TECHNICAL BULLETIN

LTB00438NAS1

'Electronic air suspension – fault' Displayed / DTC C1A36-01 Stored

Range Rover (LM)

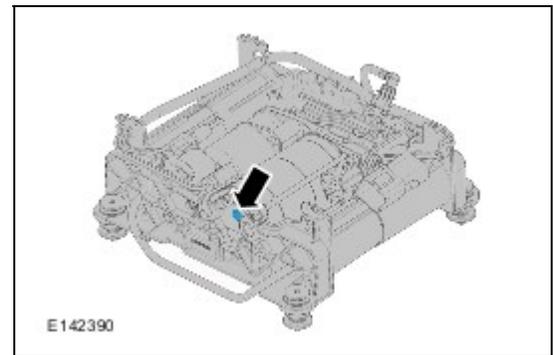
REPLACE AIR SUSPENSION COMPRESSOR AND RELAY

NOTE: Do not carry out the Air Suspension System Depressurize.

1. Refer to Workshop Manual, section 204-05: *Air Suspension Compressor*, and remove the Hitachi air suspension compressor:
 - Perform steps 1-7 only.

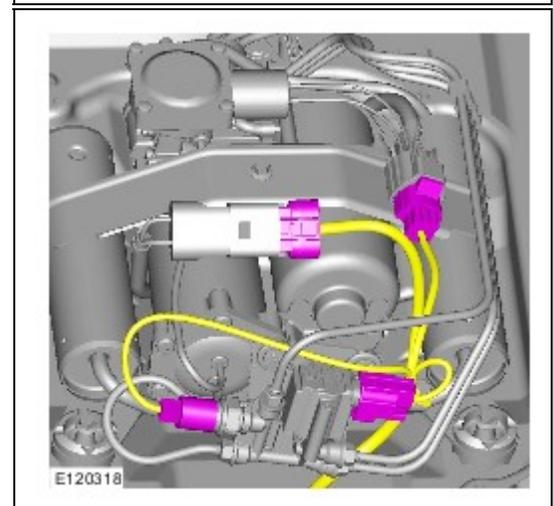
2. Fit the new AMK compressor:
 - Connect the air suspension pipe.

3. Install the four (4) securing bolts.
 - Tighten to 10 Nm.

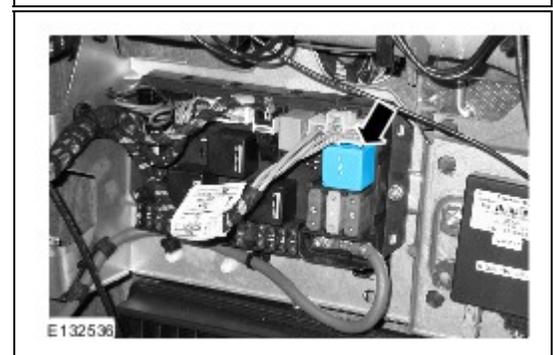
4. Mount the valve block assembly:
 - Connect the harness connectors the same way as with the Hitachi compressor.
